UNITED STATES
NUCLEAR REGULATORY COMMISSION
WASHINGTON, D. C. 20555

APPLICANT: Public Service Electric & Gas Company (PSE&G)
FACILITY: Hope Creek Generating Station
SUBJECT: SUMMARY OF STRUCTURAL AND GEOTECHNICAL ENGINEERING
BRANCH (SGEB) MEETING

On August 1, 1984, a meeting was held in the Bethesda, Maryland offices of the NRC to discuss the remaining SGEB-Structural audit open items identified in the Draft SER. A list of meeting attendees is included as Enclosure 1 to this meeting summary.

FIGURE A-16-5
 RESPONSE SPECTRA COMPARISON,
 INTAKE STRUCTURE AT ELEV. 114' - 0".

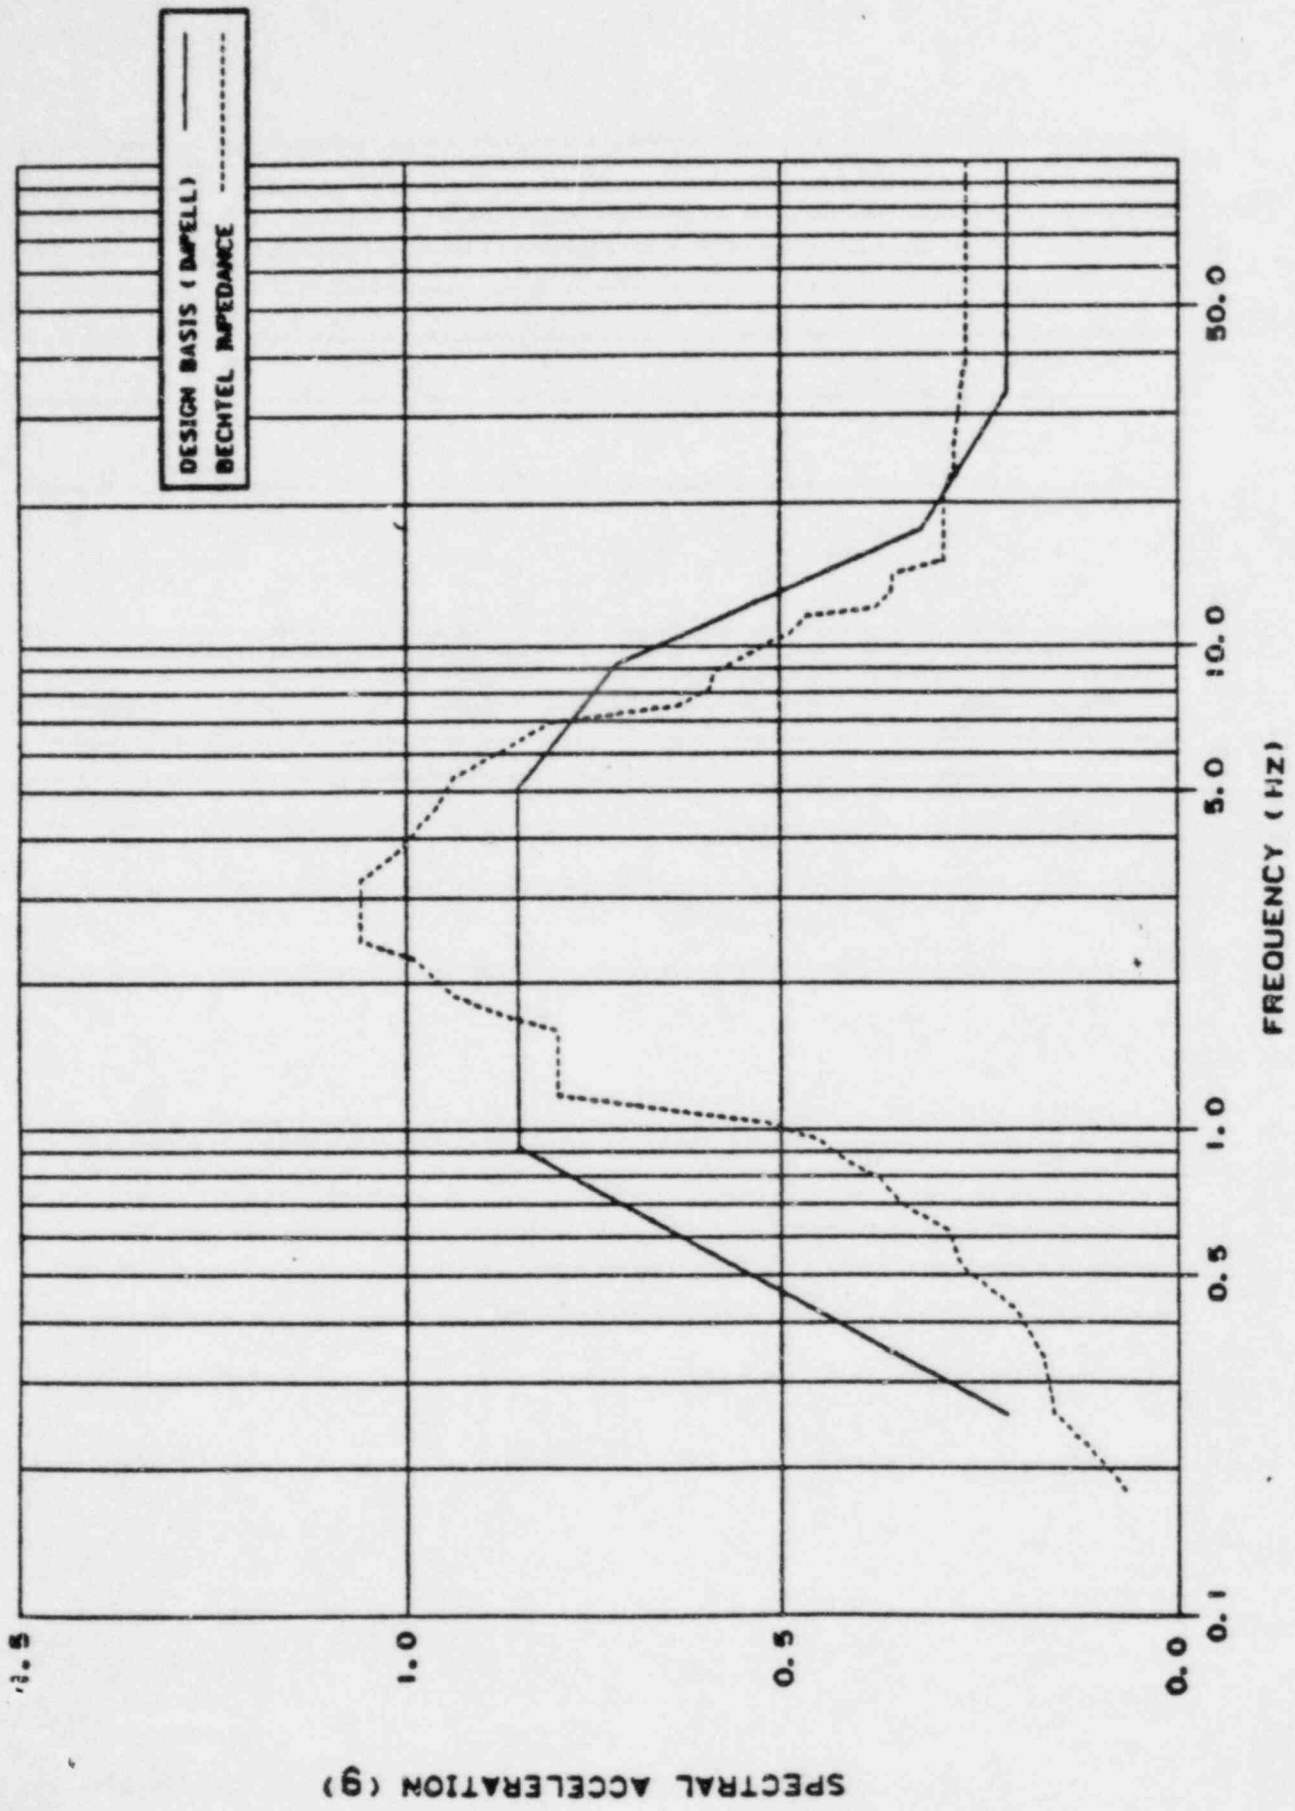
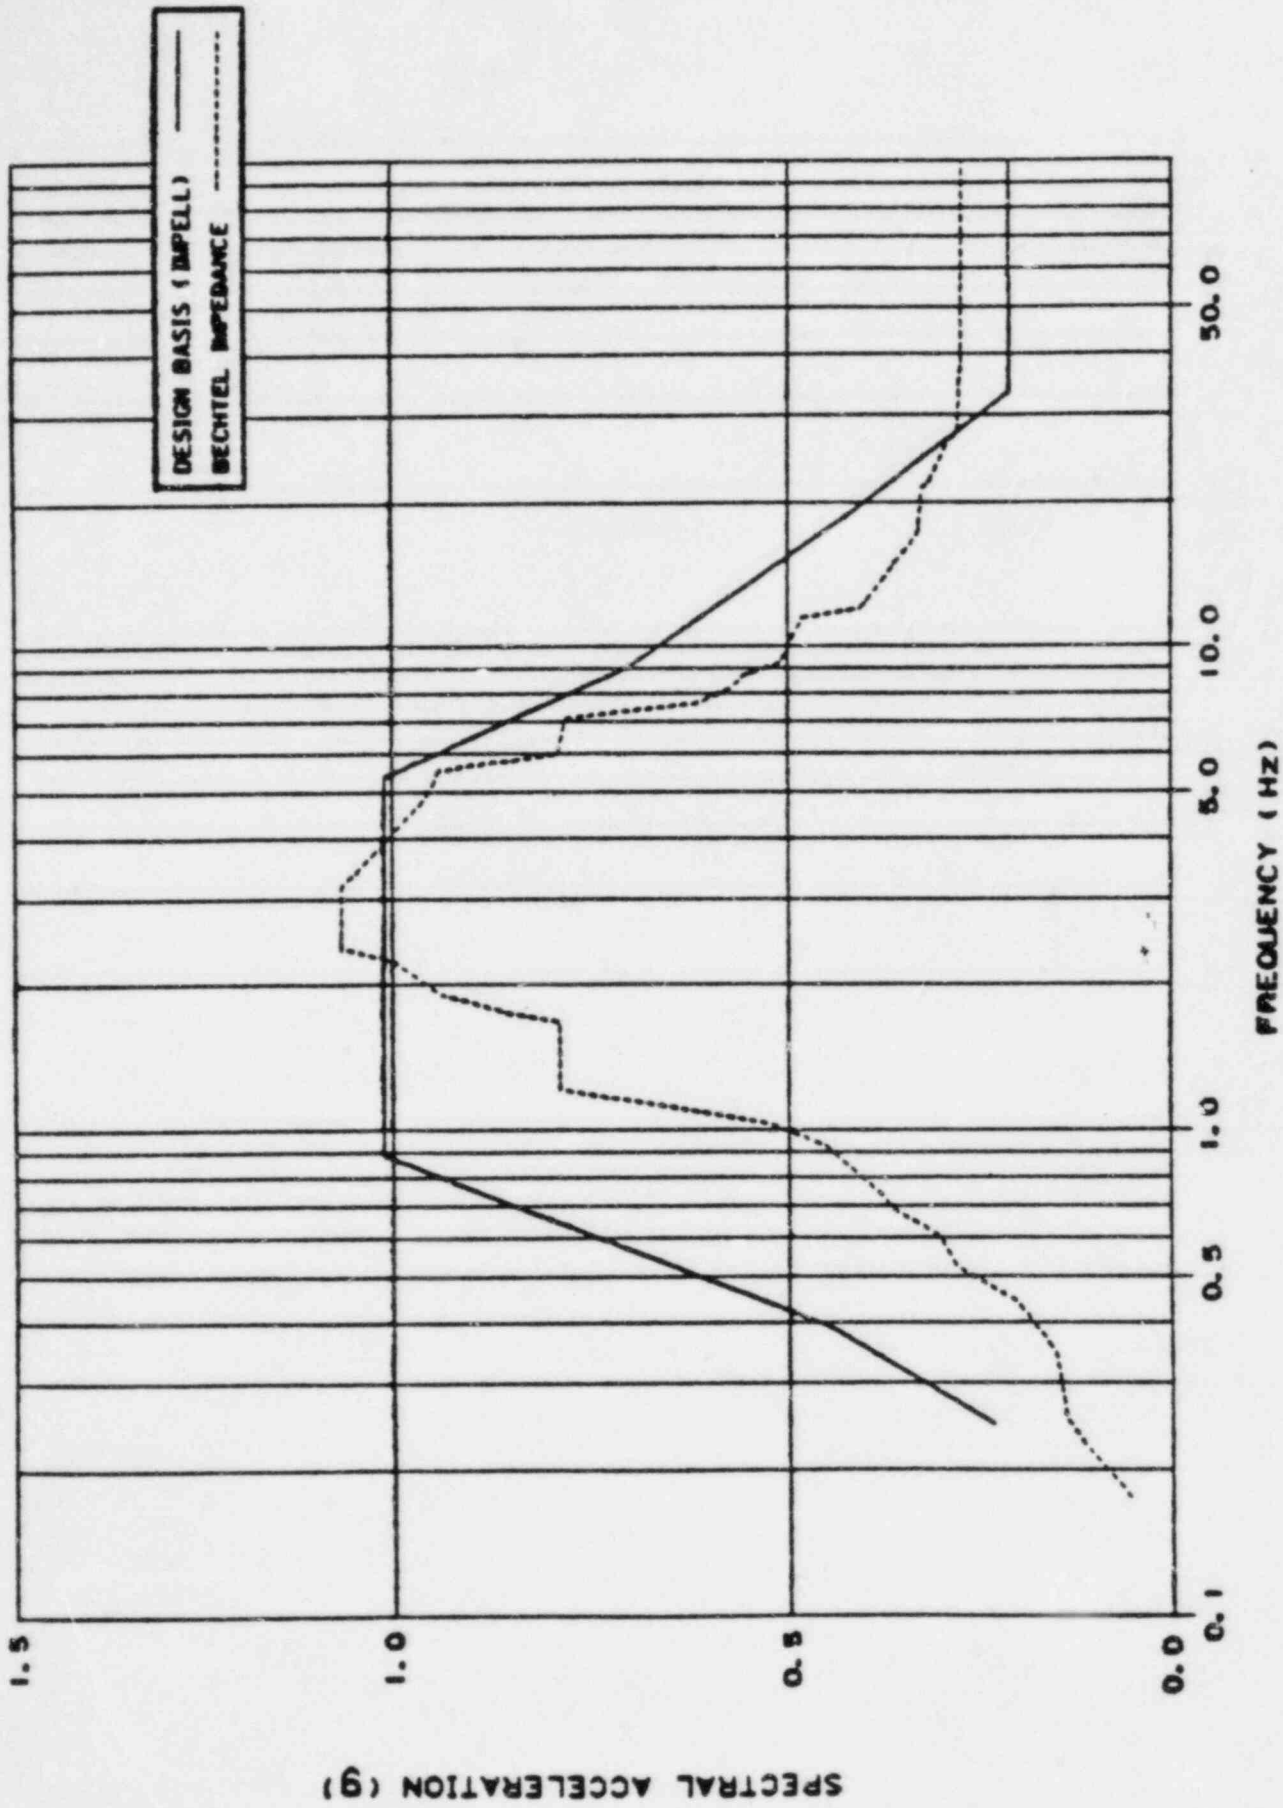
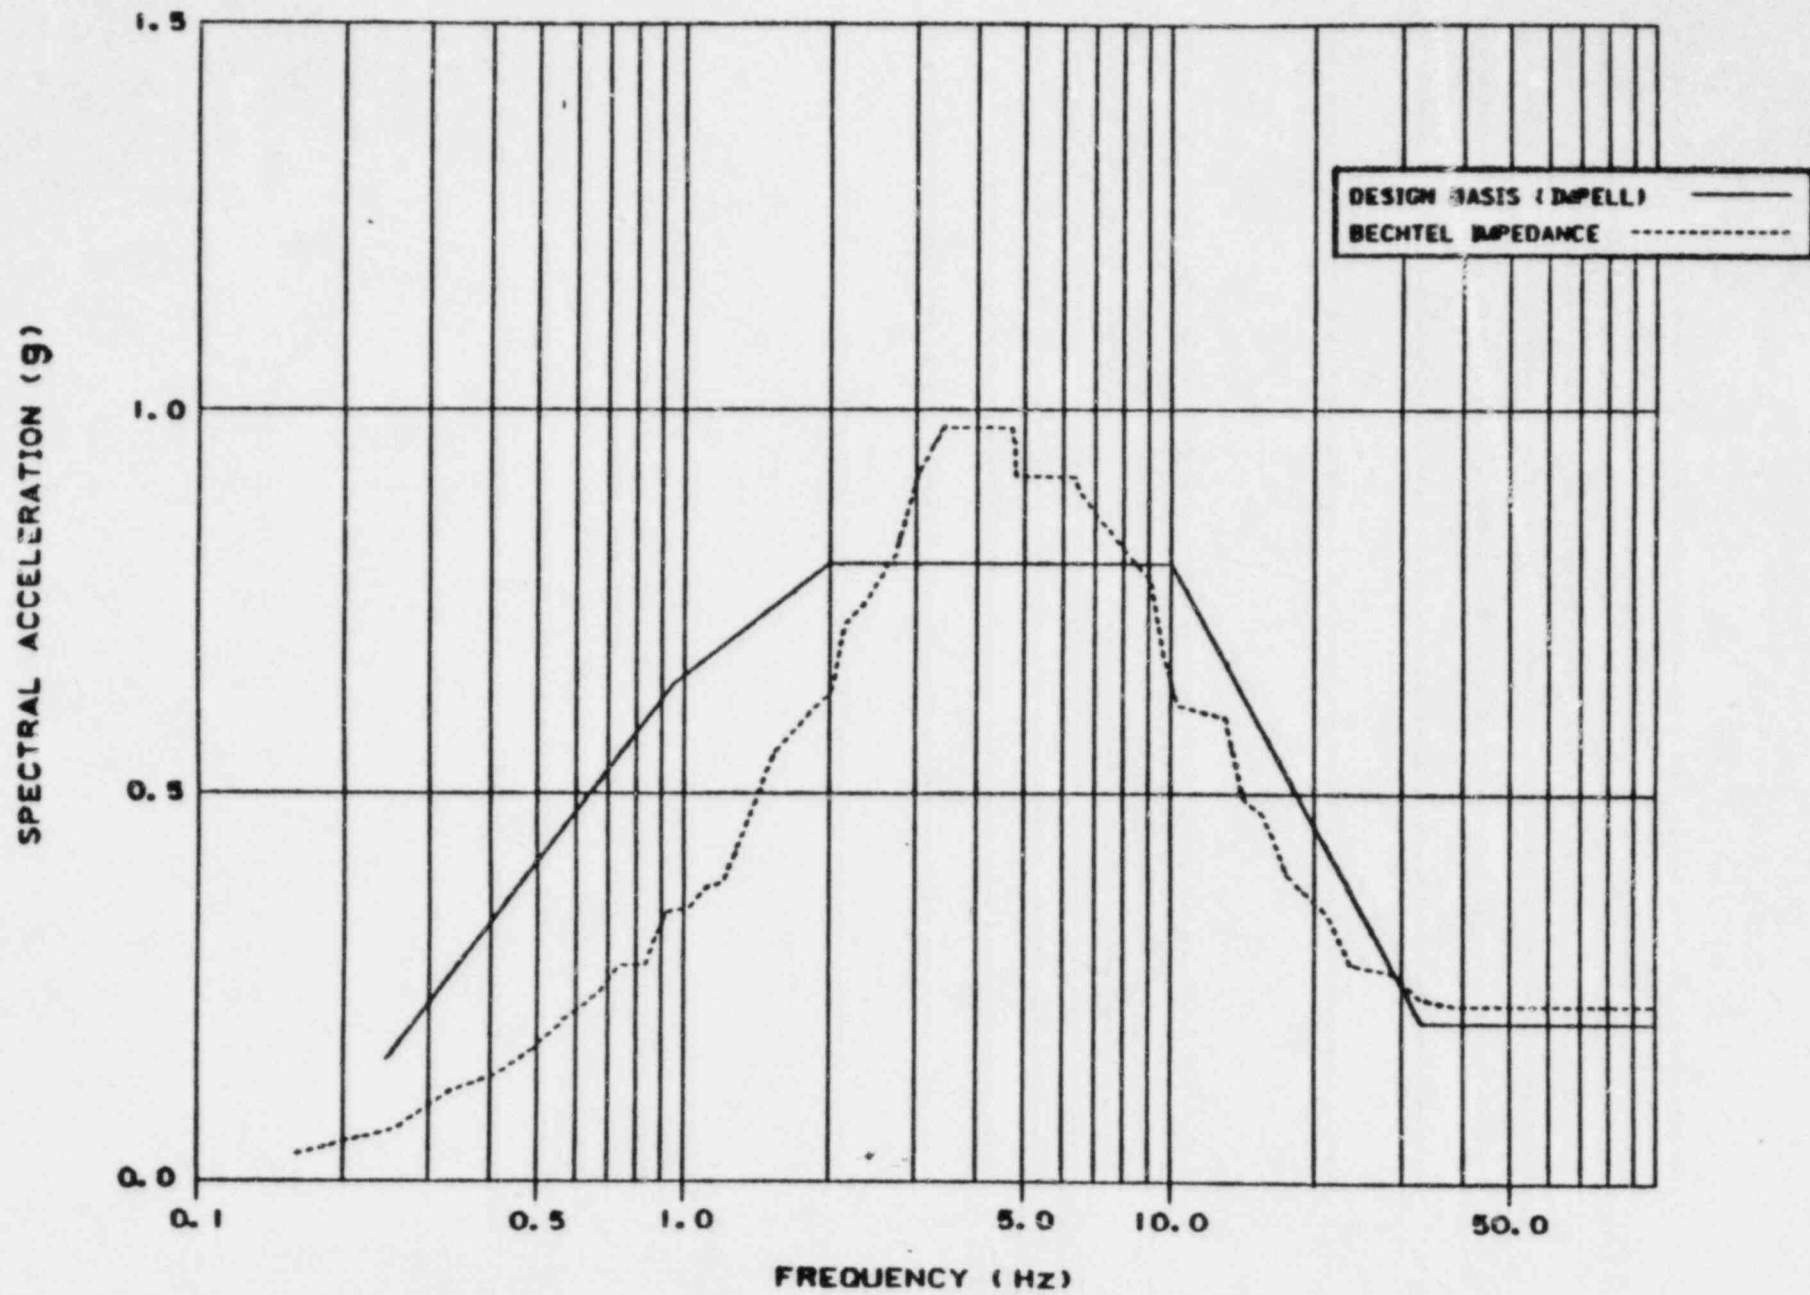
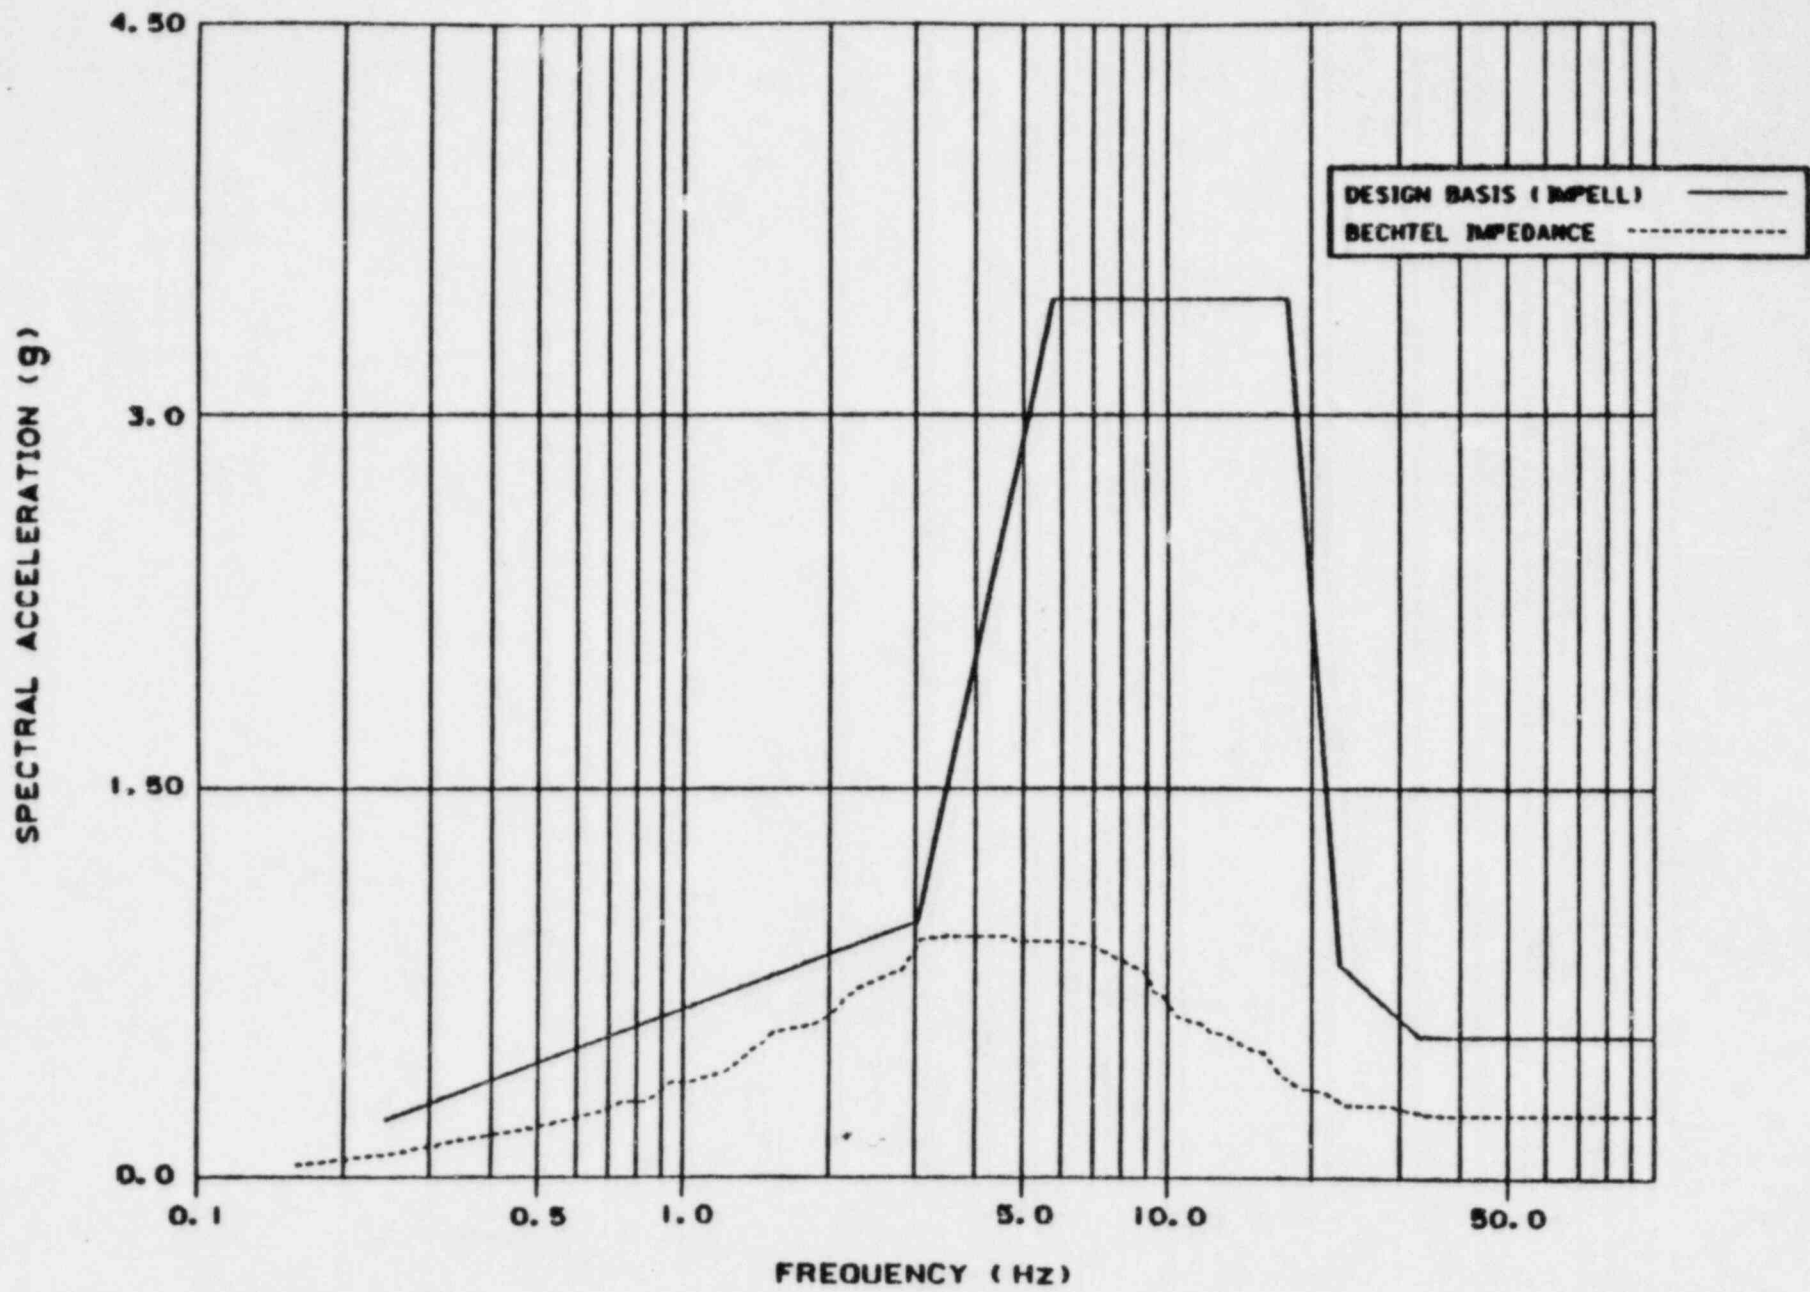
Question No.: A-16

Figures A-16-1 to A-16-18 show the comparison of the 2 percent damping response spectra obtained from the design basis finite element and the impedance approach seismic soil-structure interaction analyses. The impedance approach response spectra generally are enveloped by those obtained from the design basis analyses at elevation 114.0 feet of the SWIS. For other elevations, the impedance approach spectral accelerations exceed the design basis spectral accelerations in some frequency ranges. These ranges vary approximately between 1.5 and 10.0 Hz.
